Greater London House, Hampstead Road

Delegated Report (Members Briefing)		Analysis sheet		Expiry Date:		28/04/2025	
		N/A / attached		Consultation Expiry Date:		28/06/2025	
Officer				Application Number(s)			
Henry Yeung				2025/0912/P			
Application Address				Drawing Numbers			
Greater London House Hampstead Road London NW1 7QX				<i>Please refer to Decision Notice</i>			
PO 3/4	Area Team Signature	C&UD	Authorised Officer Signature				
Proposal(s)							
Improvements to the building entrance, including replacing the existing ramp with stairs and lifts; relocating the cat statues; demolishing ancillary structures; creating one new roof terraces for amenity use, including rooftop pavilions; repositioning PV panels; introducing soft landscaping; and carrying out associated works; the removal and repositioning of the green roof and the existing solar panels.							
Recommendation(s):		Grant planning permission					
Application Type:		Full Planning Permission

Improvements to the building entrance, including replacing the existing ramp with stairs and lifts; relocating the cat statues; demolishing ancillary structures; creating one new roof terrace for amenity use, including rooftop

Figure 2: Proposed Roof Plan

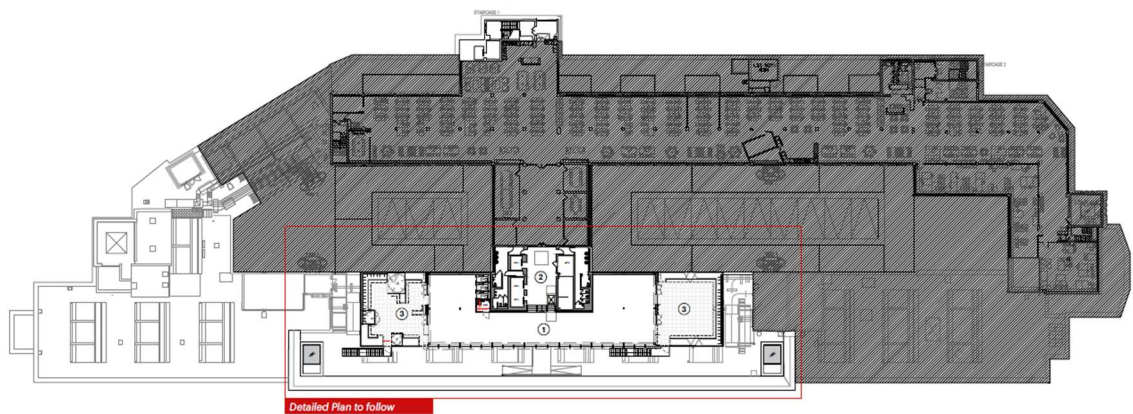
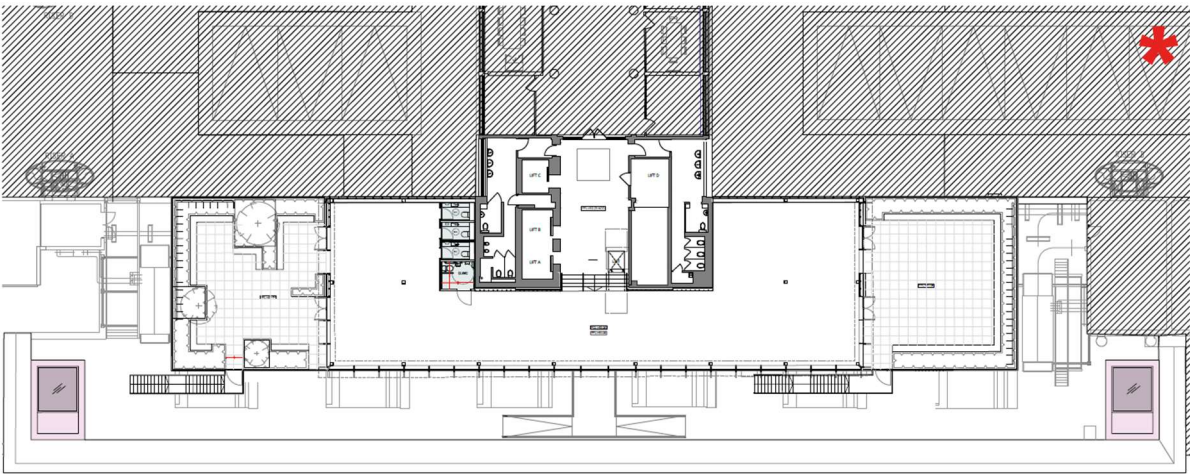
6. Proposed Rooftop Pavilion

The current design has been criticised as visually incongruous with the host building, with some comparing it to a glass box or showroom. It is suggested that the design be revised to better reflect the Egyptian Revival character of the building. This could involve drawing upon the existing colour palette, geometry, and materials of the building. The design should be sensitive and contextual without resorting to pastiche.

CTCAAC raises strong concerns about the visibility of the proposed rooftop pavilion in long views, particularly across Harrington Square during winter months. The design and materials are seen as incongruous with the host building, with fears that the pavilion would negatively impact the character and appearance of the Conservation Area.

Officers have assessed the pavilion's visual impact through site visits and verified views and, in consultation with the Council's Conservation Officers, concluded that the proposals will not cause harm to the conservation area or nearby listed buildings. The extension is viewed as an opportunity to visually and functionally upgrade the deteriorating roofscape, with appropriate boundary treatments such as matching white aluminium railings helping to ensure design coherence. Please refer to 2.4 in the report for further assessment on the design of the proposal.

The concerns raised about the visibility of the rooftop pavilion, particularly in long views across Harrington Square during the winter months, are noted. However, following a detailed assessment, including a site visit and townscape analysis, officers are satisfied that the pavilion remains visually subservient to the host building and will not result in harm to the character or appearance of the Conservation Area. The proposed design adopts a contemporary architectural language that draws upon the building's historic features without resorting to pastiche, and the use of high-quality materials will ensure a cohesive and sensitive addition.

Figure 5: Proposed Section

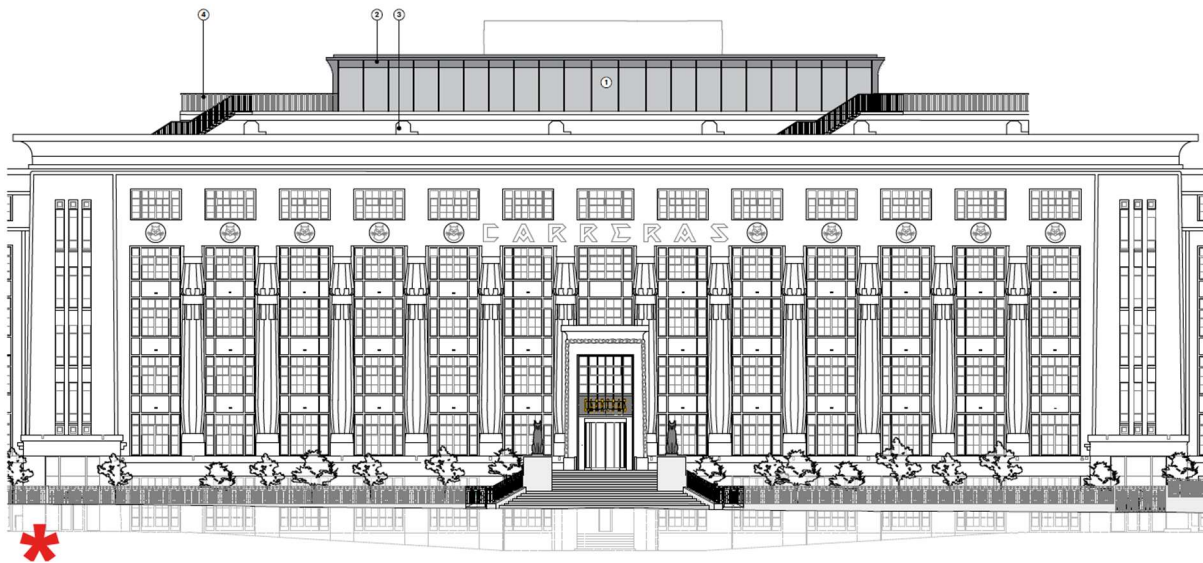
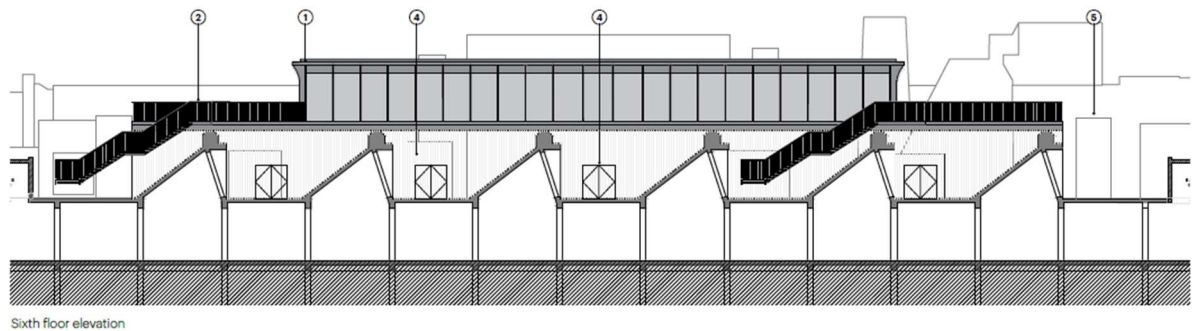
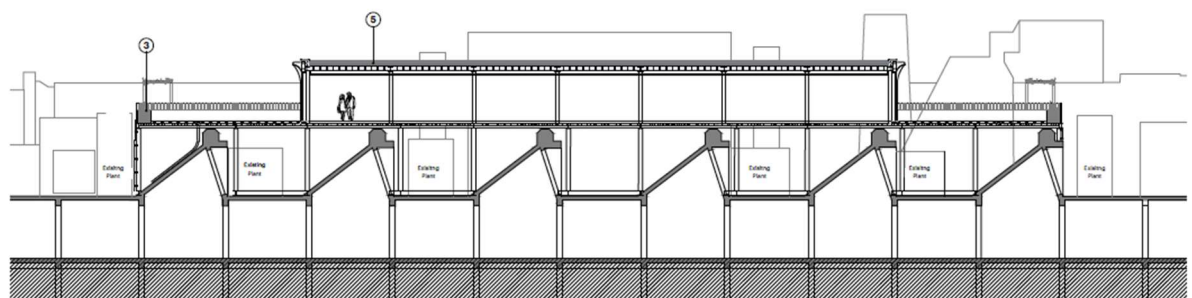
7. Terrace Staircase Layout

The proposed staircase layout to the new terraces has raised concern due to its asymmetry, which is viewed as disrupting the balance of the original building design.

Additionally, the objector highlights the asymmetrical placement of the new staircases to the terraces, which they believe conflicts with the building's existing symmetrical design. A suggestion is made to reposition the staircases to restore architectural balance.

While these comments are noted, it is important to clarify that the staircases are not prominently visible from the public realm, including key street-level views. Their location at upper levels and behind screening elements significantly limits their visual impact when viewed from ground level. Furthermore, the proposed staircase configuration has been carefully designed to optimise access and usability for office occupants, contributing to improved amenity and functionality of the terrace spaces.

Regarding the asymmetrical placement of the new terrace staircases, it is acknowledged that this represents a departure from the original symmetry of the building. However, the staircases are largely screened and not prominent in public views. The layout has been carefully considered to provide functional benefits and enhanced amenity for office users, and the overall impact on the architectural composition of the building is minimal.

Figure 10: Proposed Section and Ground Floor Plan

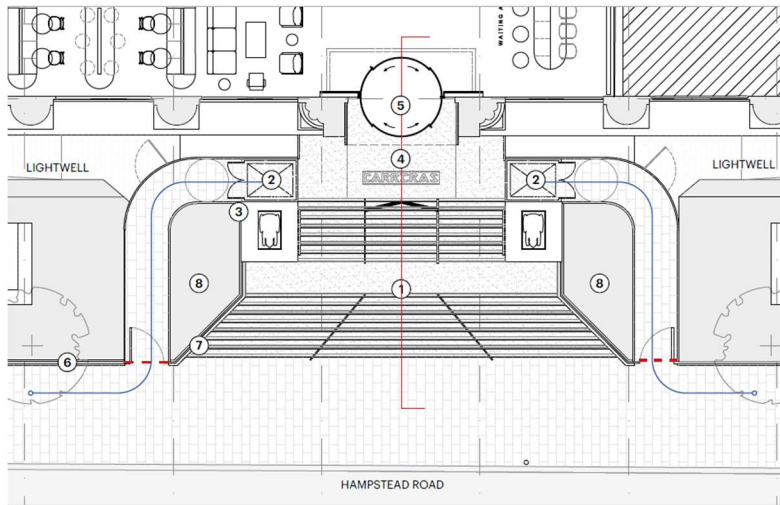
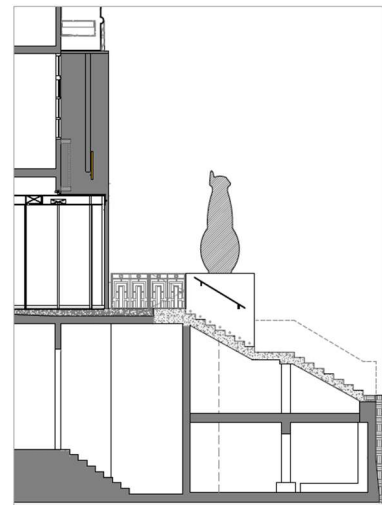
5. Front Entrance Design

The proposed placement of the cat statues halfway up the steps, which is seen as less effective than their current location.

The new design has been carefully developed to enhance accessibility to the office building, providing a more inclusive and user-friendly approach for all visitors, including those with mobility needs.
